Report of Dam Safety Assessment of Coal Combustion
Surface Impoundments
Interstate Power and Light Company
Sutherland Generating Station
Marshalltown, IA

AMEC Project No. 3-2106-0191

July 2011

Slope Stability Analyses Results Ten Most Critical Surfaces Per Analysis Sutherland Generating Station

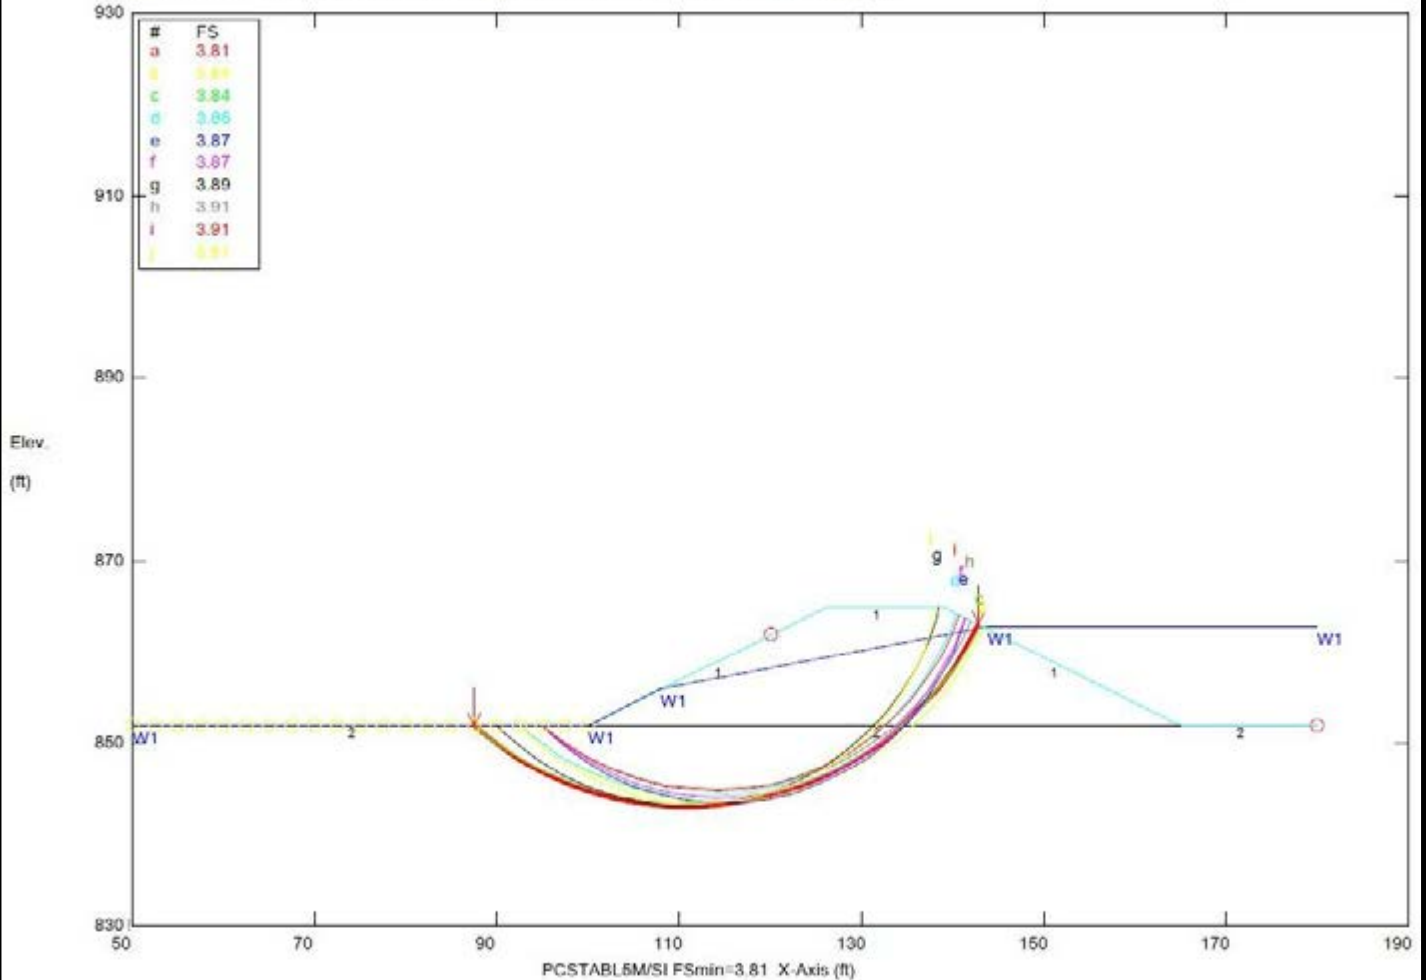
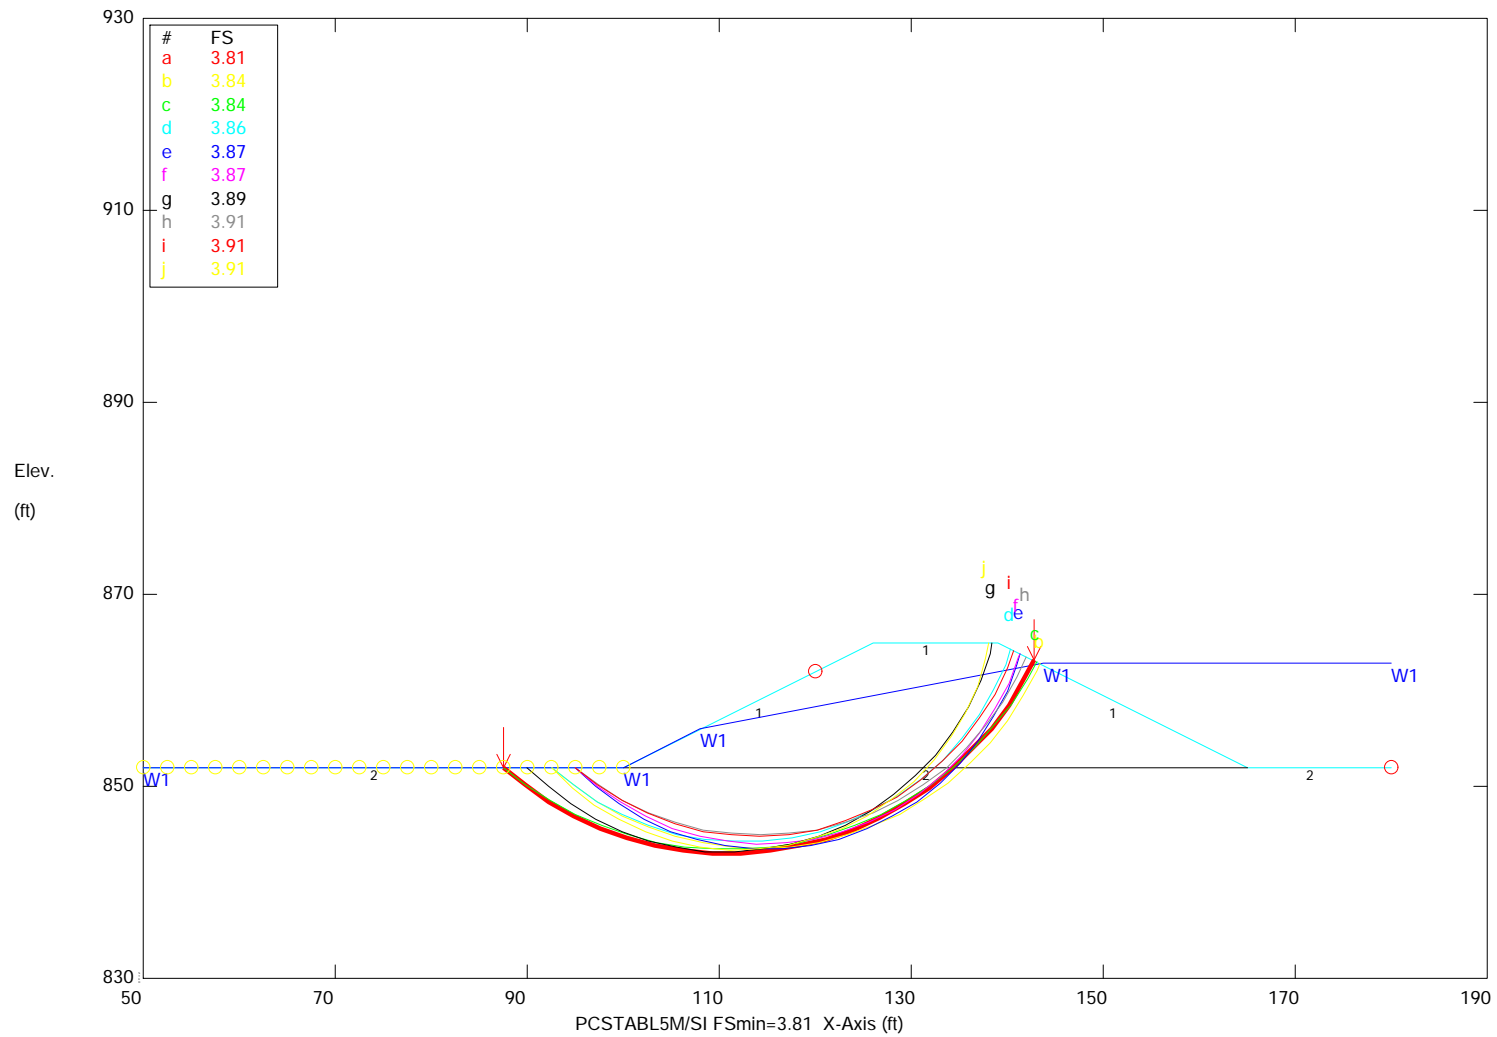
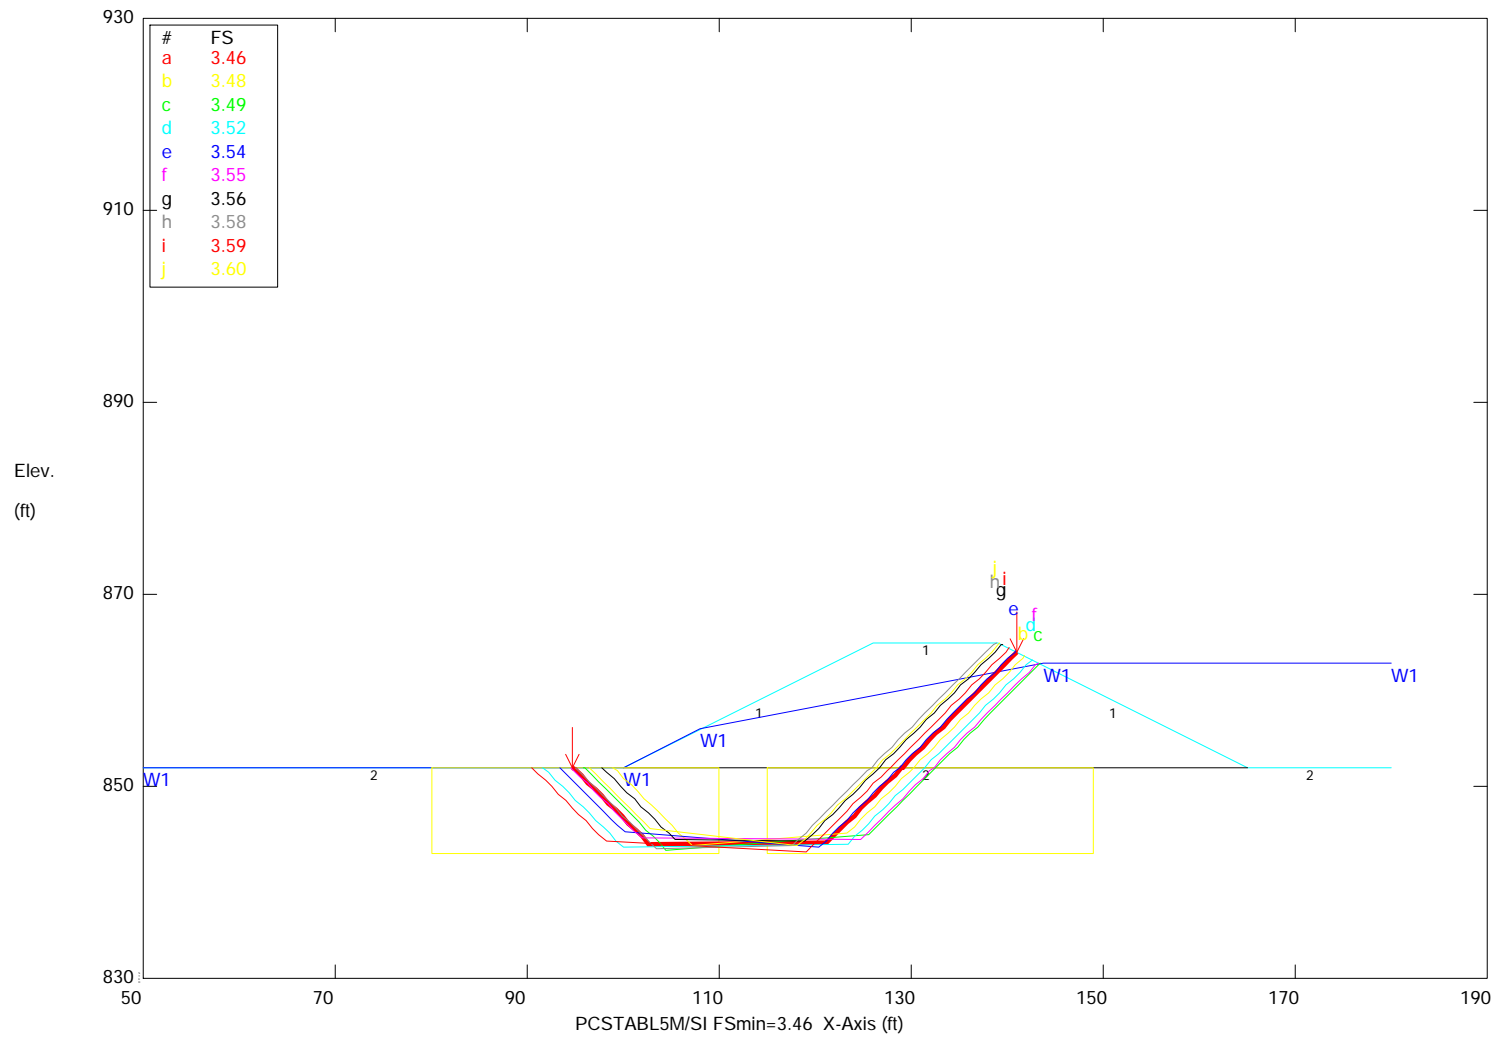
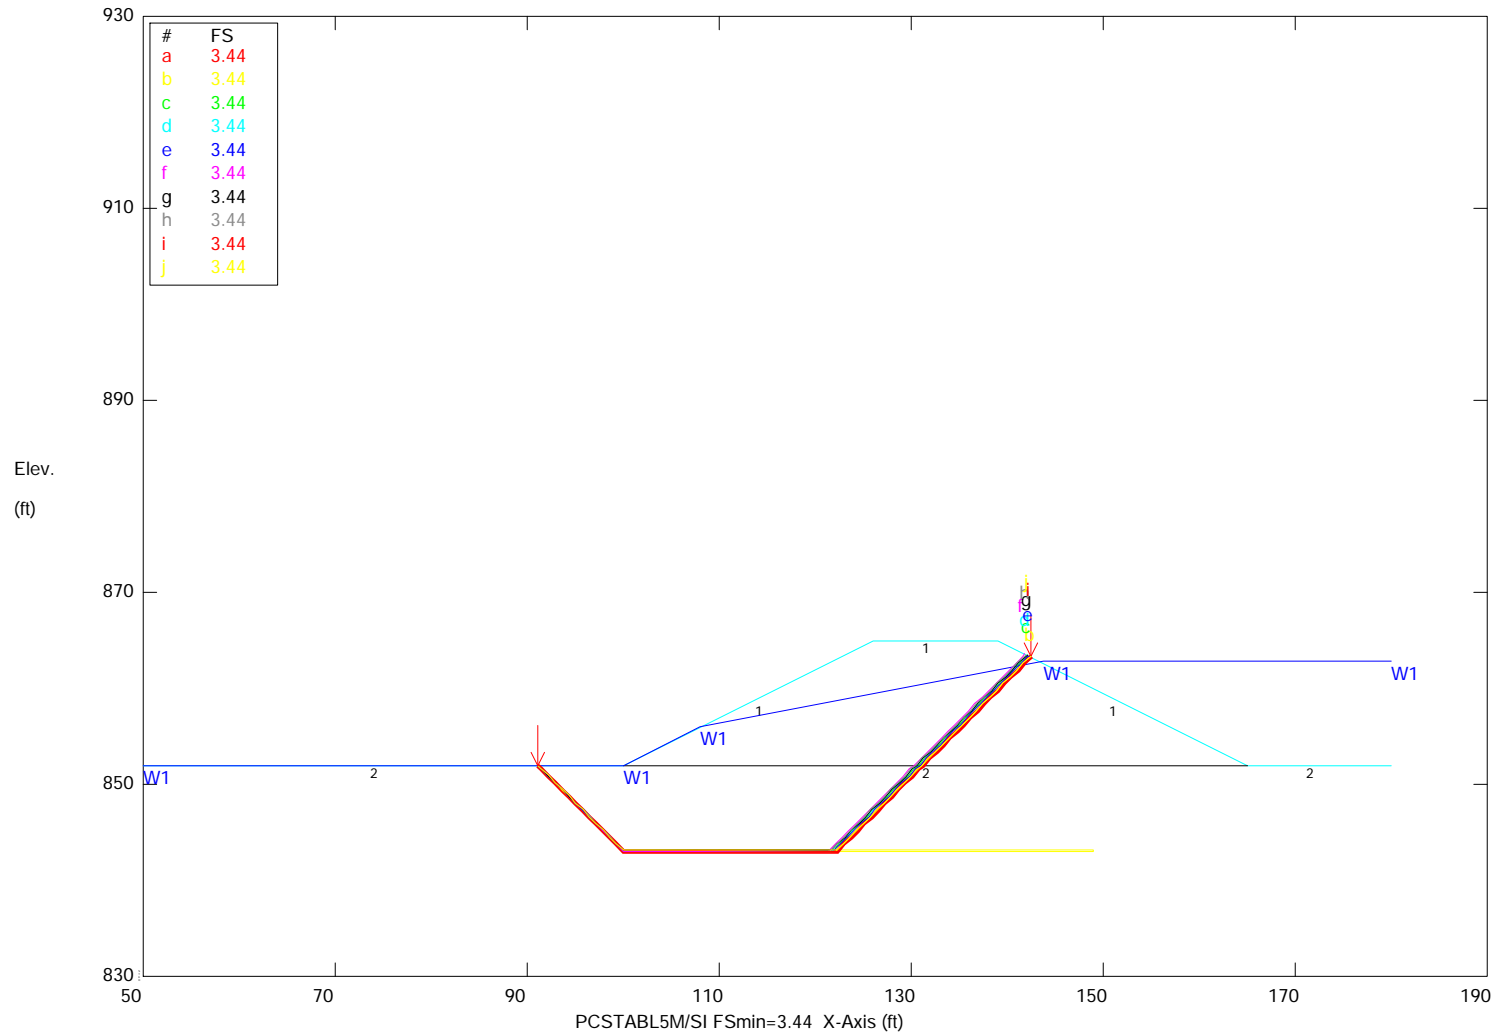
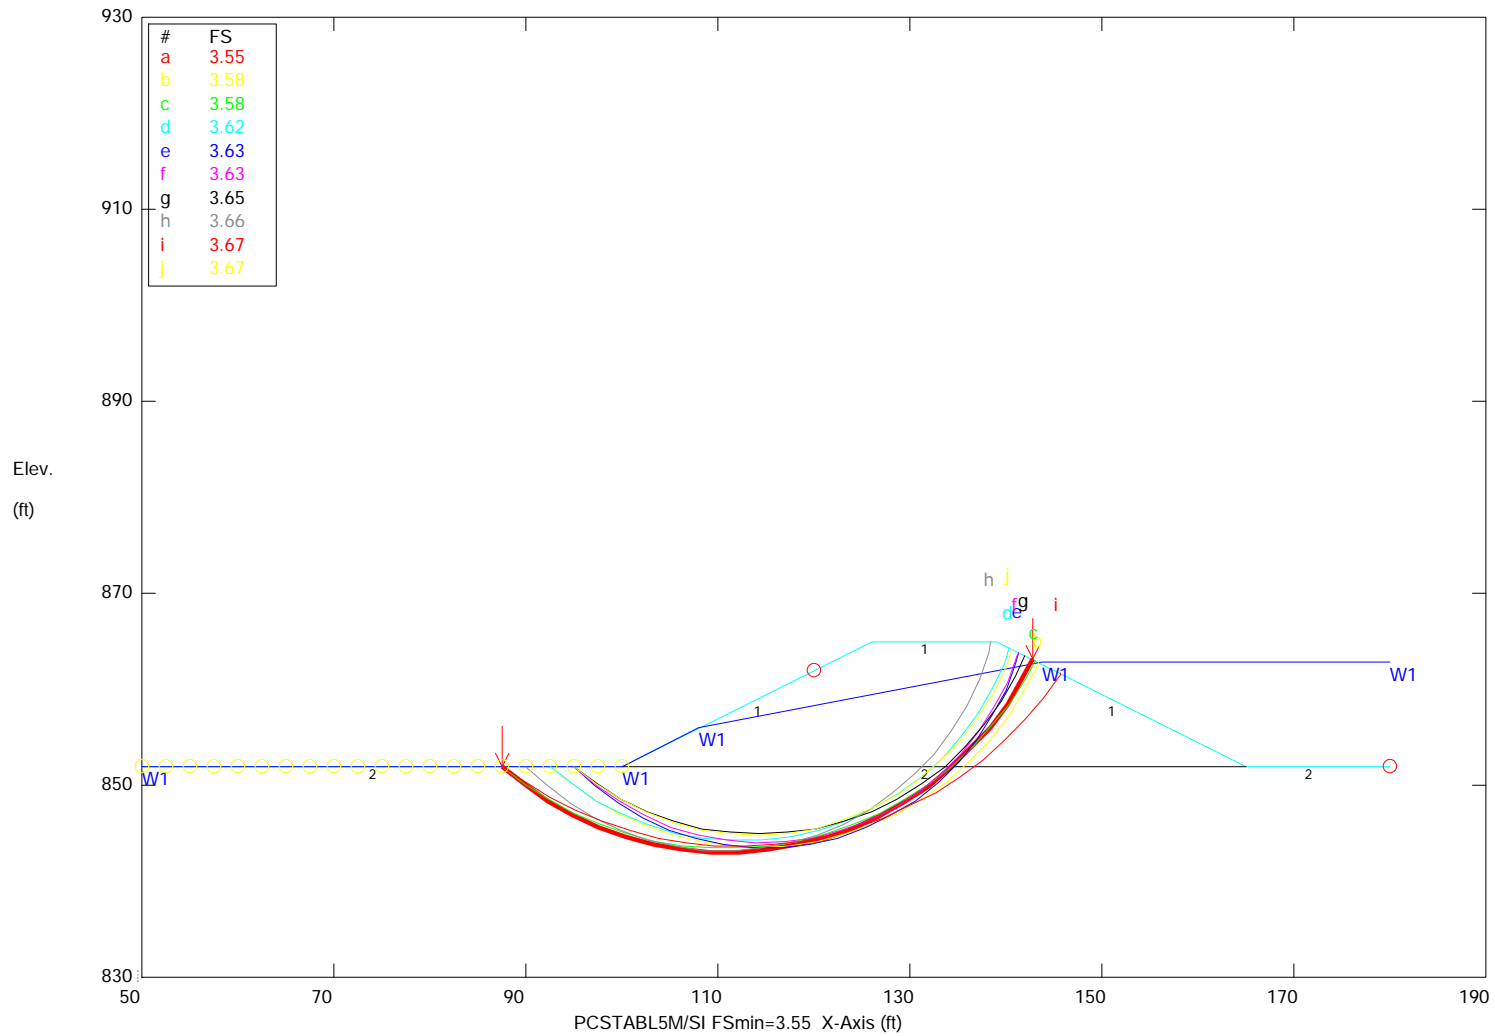
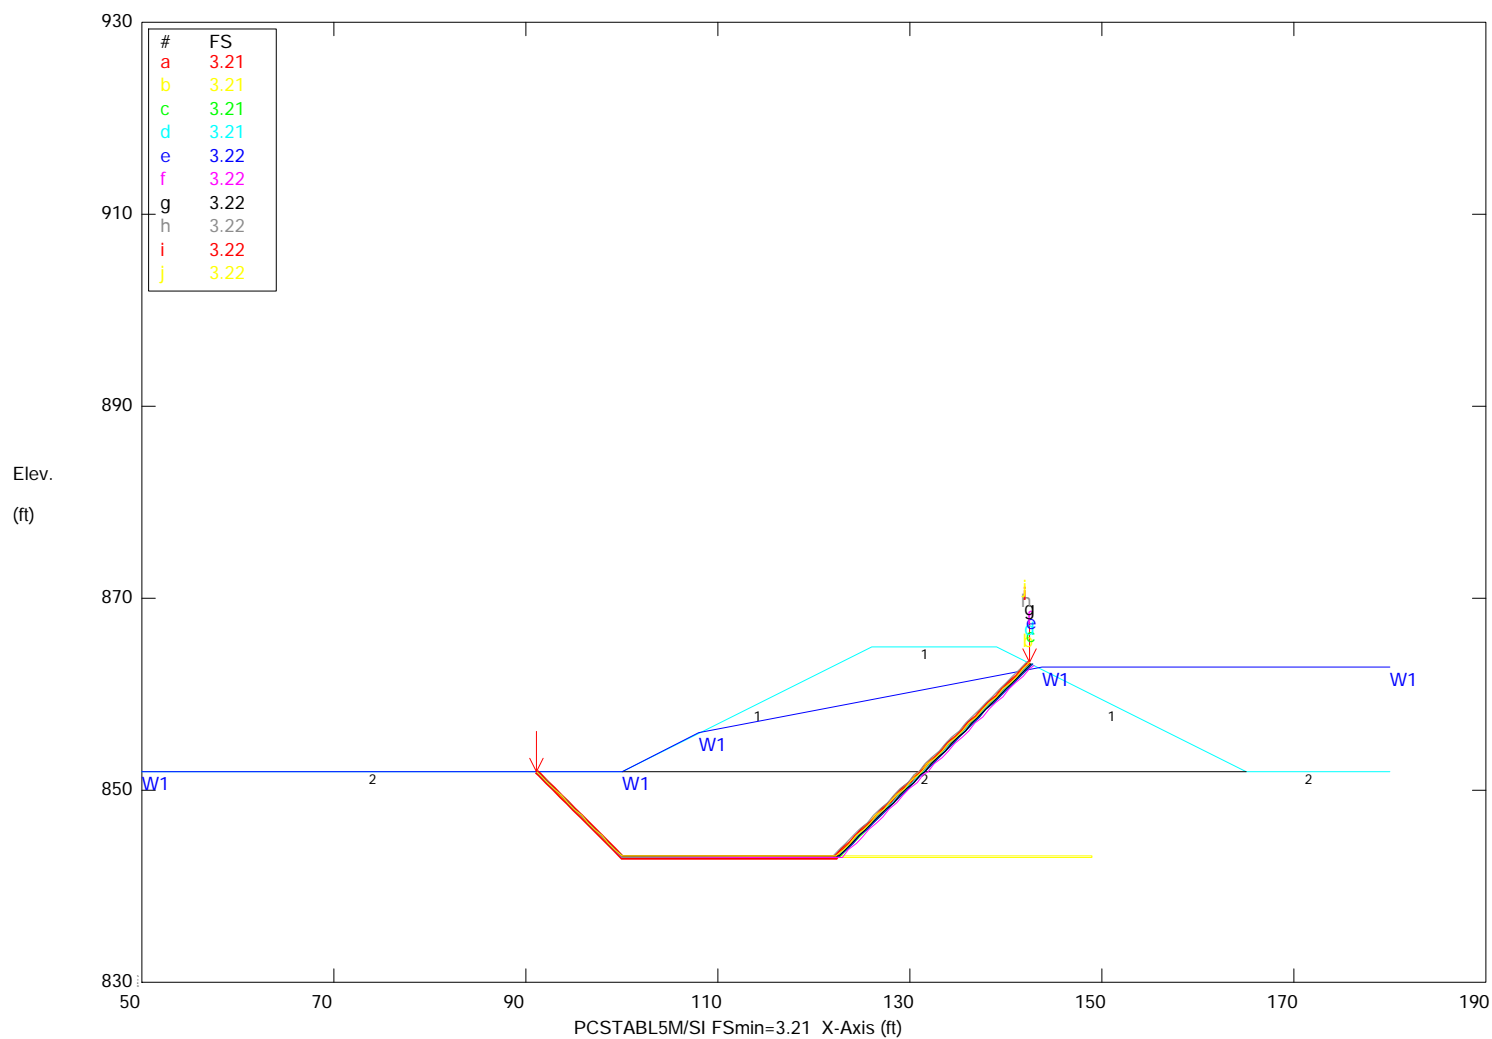
- (1) The use of pocket penetrometer tests for direct assignment of strength parameters for a stability analysis is not an acceptable method. The most widely used acceptable method to determine strength parameters is triaxial tests to determine total (short term) and effective (long term) shear strength parameters. Confined and unconfined compressive strength tests, SPT N-values and pocket penetrometer/torvane tests are used (in the same order of accuracy) to confirm the triaxial results and provide supplemental data for any indications of softer soils. The supplemental data may influence the evaluating engineer to reduce the triaxial test values. Alternatively, extremely conservative values could be used based more on the type of soils and SPT values.

- (3) The SPT and CPT borings performed during the geotechnical exploration extended to a maximum depth of 15 feet. Records from surrounding deep borings indicate sand at a depth of about 17 feet below the ash management area and about 4 feet below the toe of the embankment. Aether's extension of the clay layer below the embankment would be conservative if extremely low strength parameters were used. However, results of the analyses show deep failure surfaces. Steeper slopes, like 2H:1V modeled here, are more prone to failure at shallower depths especially given the underlying sand foundation. It appears Aether placed the minimum depth of slices too deep and is subsequently getting factors of safety results higher than actually exist.

In the assessing engineer's opinion, the method and procedural errors described above render the Aether results unacceptable. We would also like to note the attachments with the STABL5M stability results were confusing. A circular and block analysis was evaluated for both cases, but another block analyses was presented with different results and no designation or explanation provided on the plots or in the report text.

- Be revised to represent long term conditions. Pocket Penetrometer tests should not be used alone to assign strength parameters. Additional borings and lab testing should be performed to obtain sufficient data or the use of conservative values should be evaluated by a geotechnical engineer to determine if their use is sufficient or additional data is needed.
- Be revised to include actual measurements across sections of the south dike to confirm representation of the section. Steep banks were observed on the upstream slope,

- Evaluate the conditions on the east dike where water is against the toe of the embankment. If the water is not removed, this section should also be analyzed in relation to the high phreatic surface and soft foundation conditions.
- Consider all critical stages over the life of the pond including pond full conditions. These conditions would need to be determined in conjunction with the hydraulic recommendations above. The hydrologic and hydraulic analysis will provide maximum water levels in the pond and a phreatic surface through the embankment.
- A rapid-drawdown should be performed for the upstream embankment in relation to conditions when the pond would be drained.
- Consideration should be given for lowering strength values to account for inconsistencies within the fill or foundation materials.
